# Randwick Local Planning Panel (Public) Meeting

## Development Application Report No. D18/25

**Subject:** 1 Mount Street, Coogee (DA/59/2025)

**Figure 10:** Council markup of GFA basement plan (Source: Fyffe Design with Council markup)

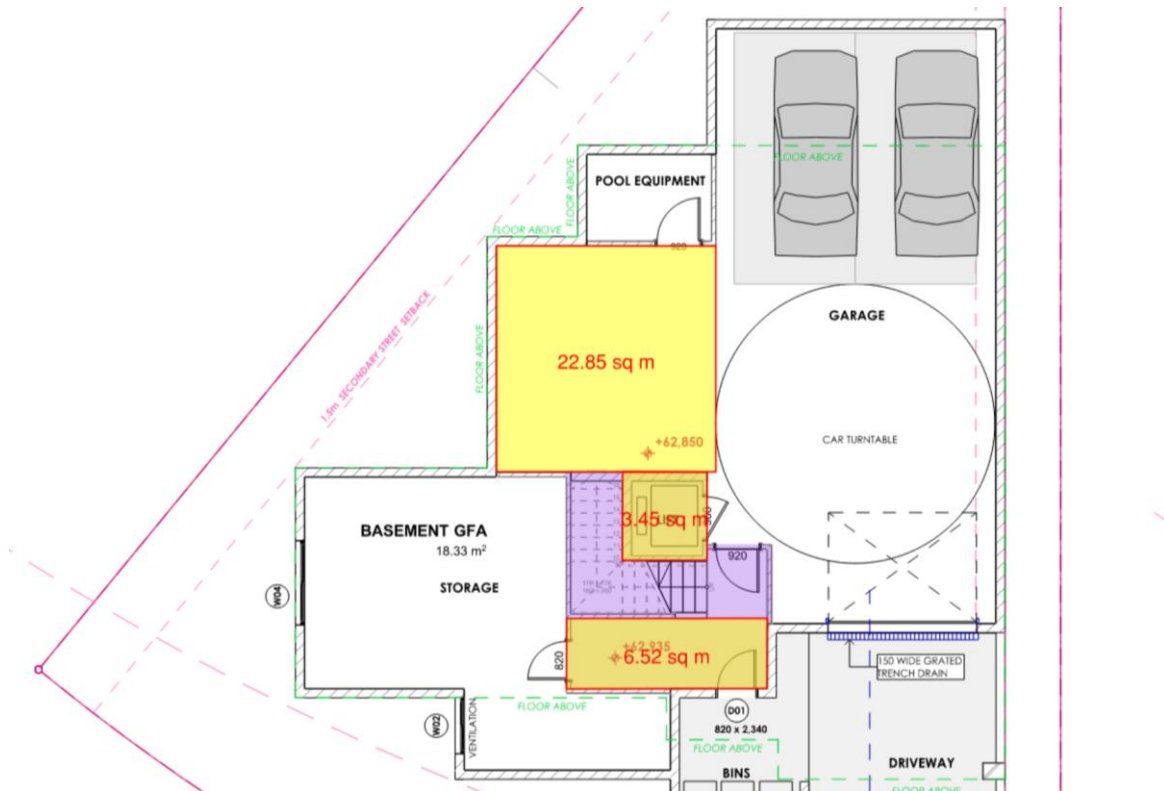
Council is not satisfied that the submitted gross floor area (GFA) plans are correct for the basement level. The area to the north of the car turntable does not constitute access to car parking and so should be included as GFA. The submitted swept path diagrams demonstrate that this area is not required for manoeuvring cars in/out of the basement in a forward direction.

Notwithstanding, the area of the internal stair and landing can be excluded at basement level as it constitutes access to car parking. Based on Council’s calculations (refer yellow highlight at Figure 10), 32.82m<sup>2</sup> of GFA is proposed at basement level.

The proposed total GFA of 302.81m<sup>2</sup> equates to a floor space ratio (FSR) of 0.739:1, which complies with the maximum 0.75:1 development standard.

**Figure 13:** Council markup of west (front) elevation plan (Source: Fyffe Design with Council markup)

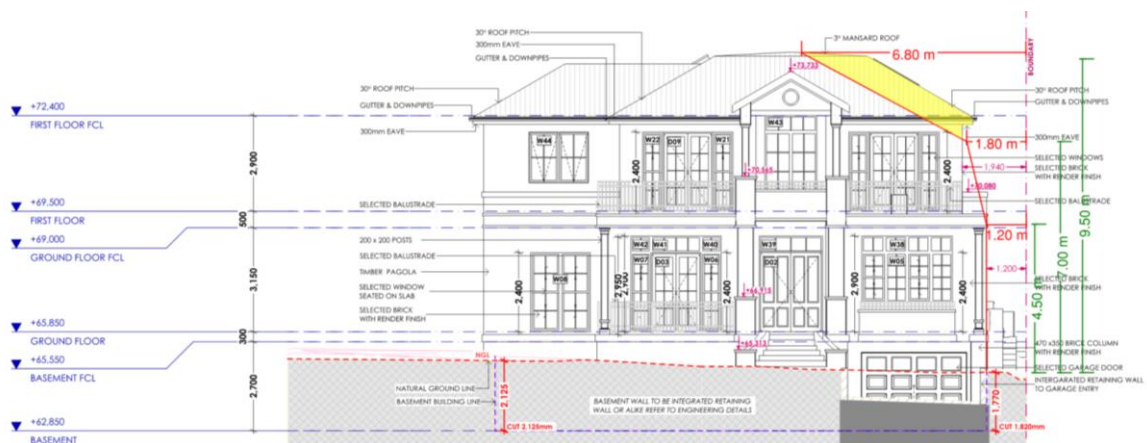
As shown in Figures 13-14, the proposal generally complies with the minimum setback distances. Whilst a minor portion of the roof form encroaches within the setback area (refer yellow highlight), numeric non-compliance is acceptable in this instance as it is partly due to the irregular shape of the site. The non-compliant portion of the building does not contain any window openings which would result in overlooking impacts to neighbouring properties.

Insistence on strict compliance with the DCP controls would result in an irregular roof form which would be incompatible with the ‘French Provincial’ architectural style of the dwelling. Additionally, it is considered that a fully compliant dwelling would not result in any substantially improved solar access outcomes for neighbouring properties.

Figure 15: Mark-up of south elevation plan (Source: Fyffe Design)

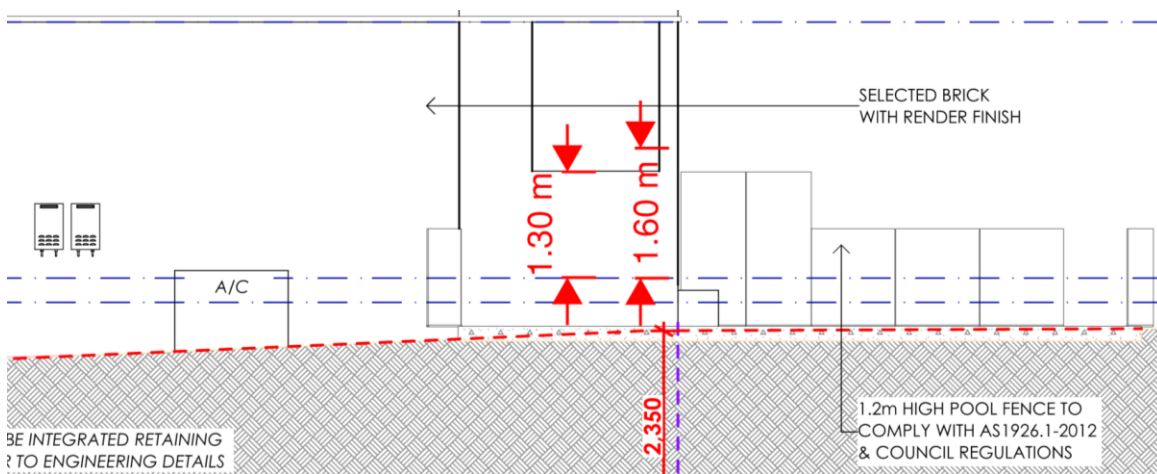
Concern is raised regarding potential overlooking from the proposed south-facing windows (at first floor level) to the property at No. 3 Mount Street. In accordance with the DCP requirements, a condition is included to ensure that raised sill heights (1.6m above FFL) or privacy glazing/screening is provided to Windows W30, W31, W32, W33, and W34.

Concern is raised regarding potential overlooking from the rear deck at ground floor level, which is raised above existing ground level. As such, a condition is included to ensure that the southern wall is raised from 1.3m (as proposed) to a minimum of 1.6m above FFL (refer to Figure 15).

Figure 16: Overlay of ground floor plan (red) and survey plan (green) (Source: Fyffe Design and G&R Surveying Services)

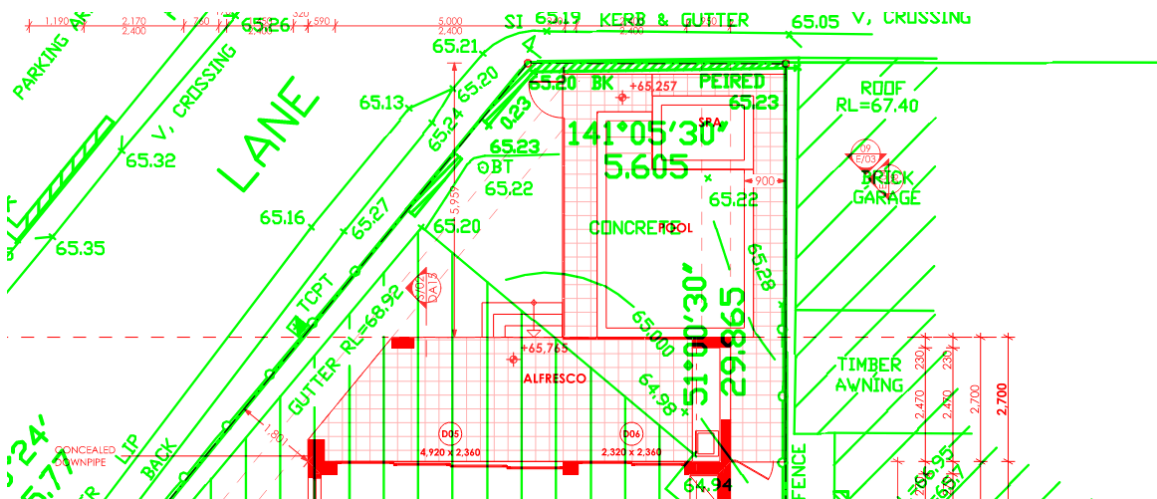
As shown in Figure 16, the rear pool (and associated decking) directly adjoins a garage at No. 3 Mount Street. The existing garage will suitably screen the pool and deck from the rear yard at No. 3 Mount Street.

**Figure 17:** Existing view corridor from No. 1A Mount Street (Source: Fyffe Design)

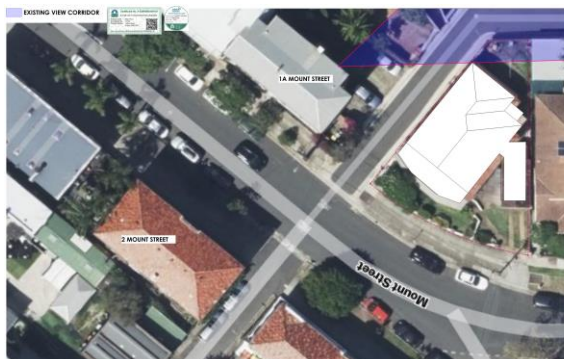
As shown in Figures 17-18, existing views from apartments at No. 1A Mount Street will be uninterrupted by the proposed development. In fact, noting that the proposed dwelling provides an increased rear setback (relative to the existing dwelling), additional view corridors may be afforded to these apartments.

Additionally, it is noted that there are no south-facing window or balcony openings at No. 1A Mount Street which directly overlook the subject site. The east-facing openings are generally oriented away from the subject site.

Figure 23: Existing view corridor from No. 2 Mount Street (Source: Fyffe Design)

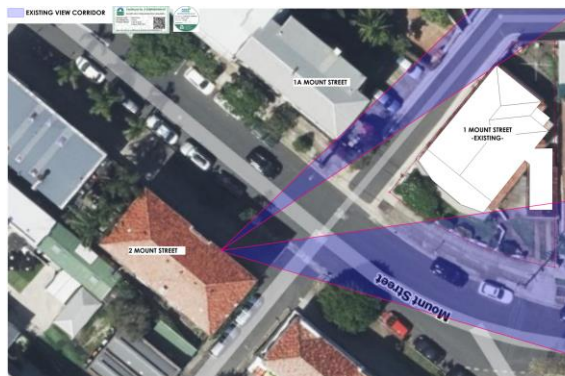
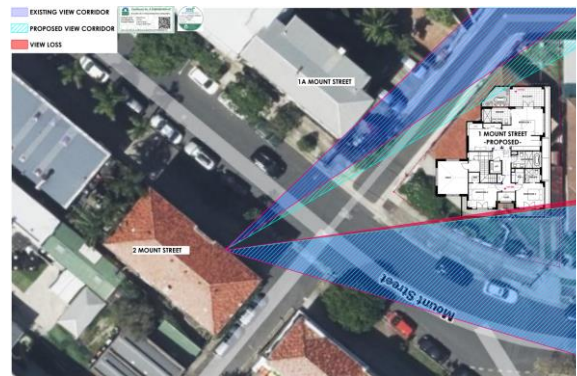
The Court poses two (2) questions in *Tenacity Consulting v Warringah Council [2004] NSWLEC 140* at paragraphs 23-33. The first question relates to whether a non-compliance with one (1) or more planning controls results in view loss. The second question relates to whether a more skilful design could provide the same development potential whilst reducing the impact on views.
